REMARKS/ARGUMENTS

Application No. 10/732,726
Reply to Office Action dated May 23, 2005
Annotated Sheet Showing Changes

Fig 6

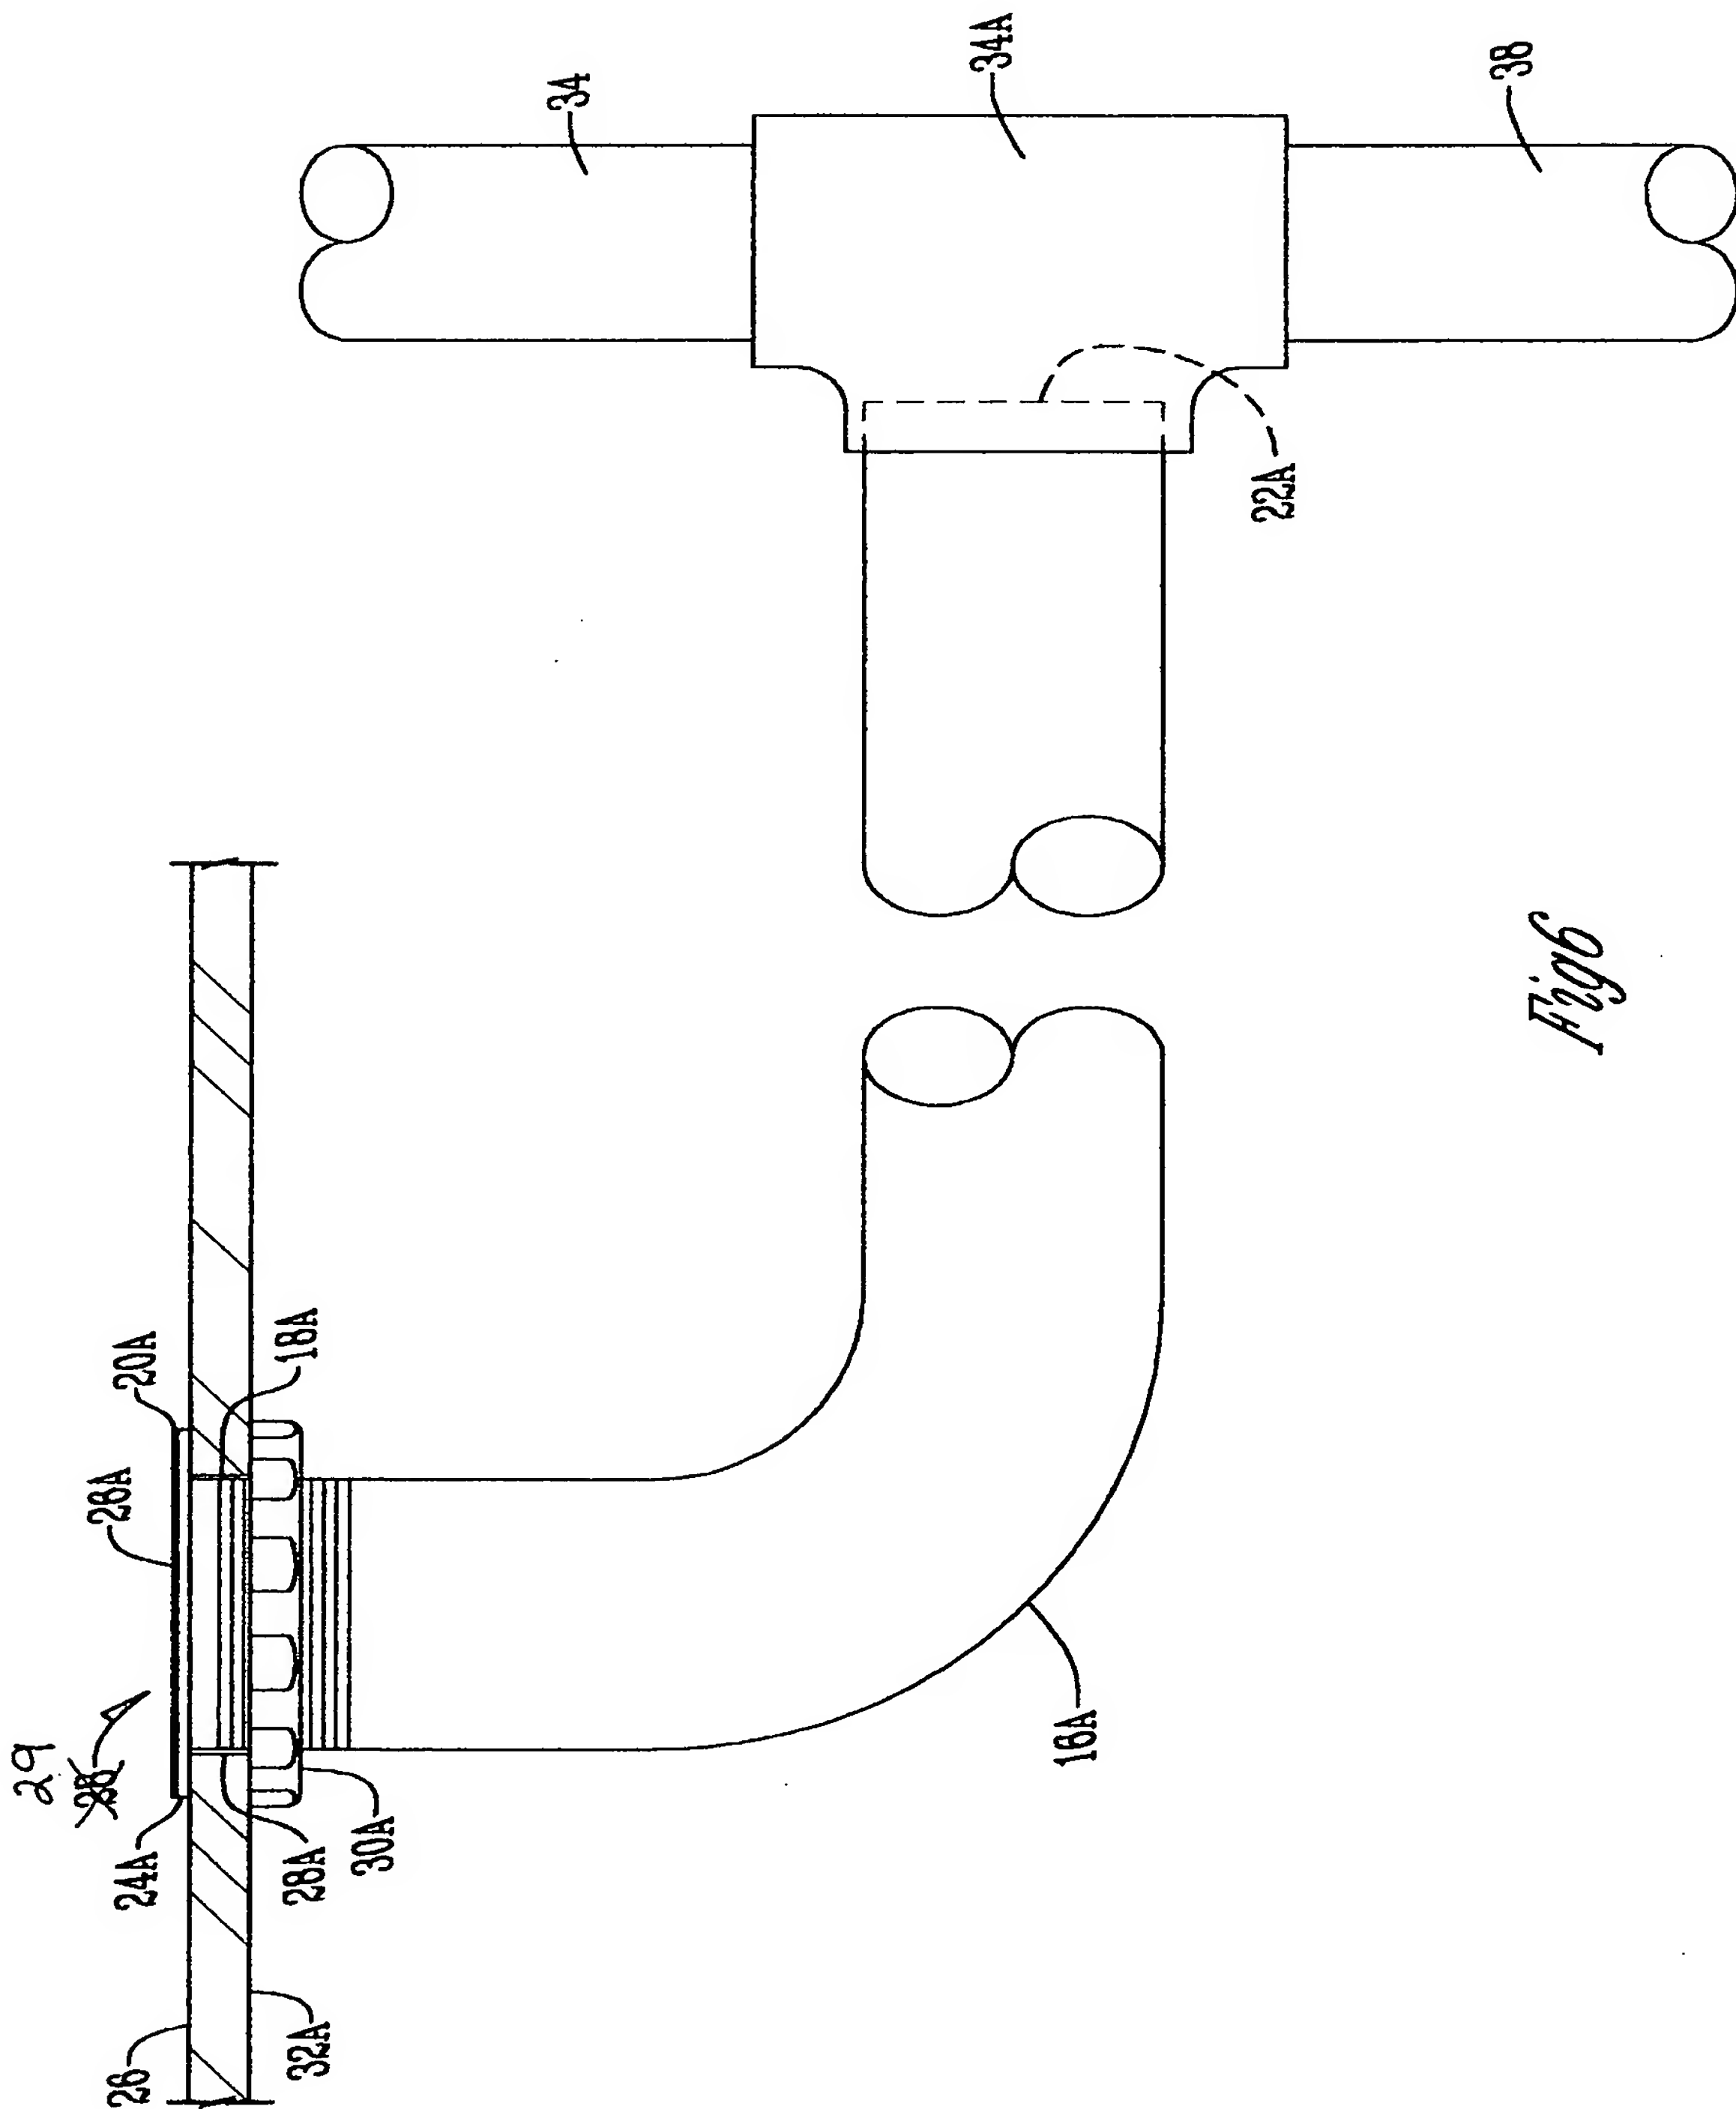
The attached sheet of drawings includes changes to Fig. 6 and new Fig. 8. This sheet, which includes Fig. 6, replaces the original sheet including Fig. 6. In Fig. 6, element 28 was changed to element 29. New Fig. 8 was added and shows a flow chart of a method of conducting a fluid leakage test.
